Subject: Requesting Class II permissive change for FCC ID : **2ASXC-TMO-NBT-01**

## Add a Metal Sheet for Button

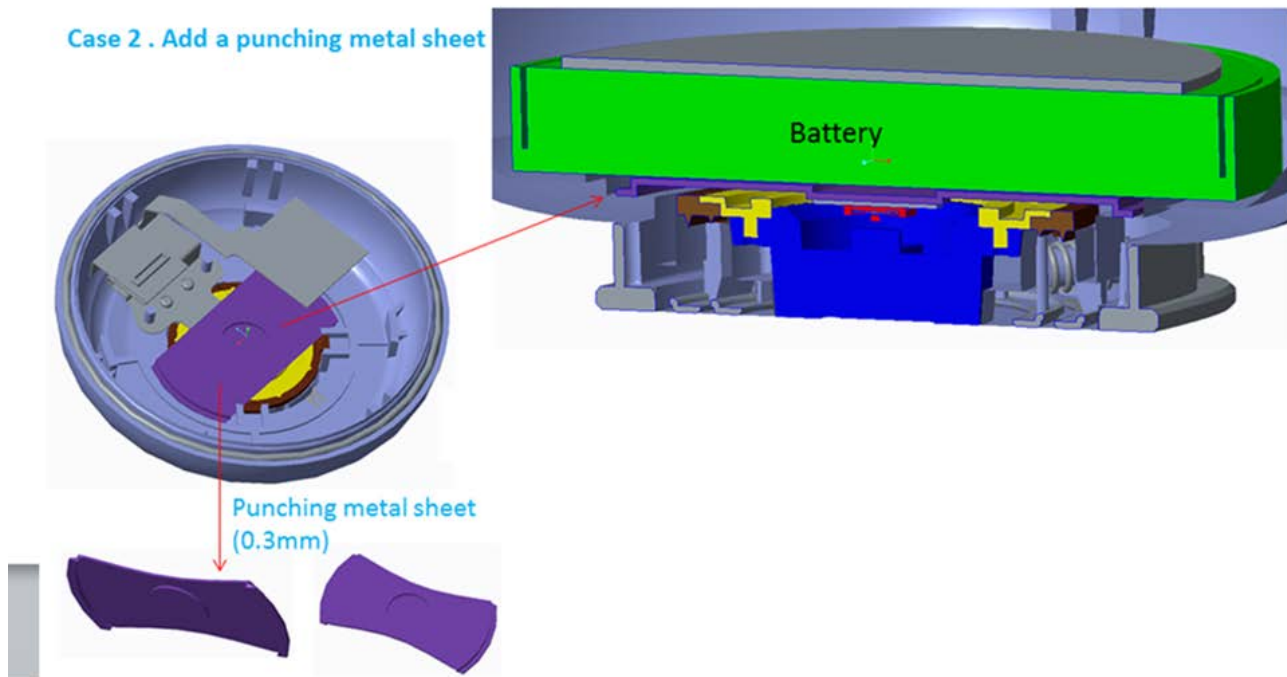
add a metal sheet for button as below shows :

Case 2 . Add a punching metal sheet

The proposed change does not affect the conducted output power or antenna gain therefore testing was limited to just radiated spurious emissions. RF exposure was not reassessed because output power remains unchanged
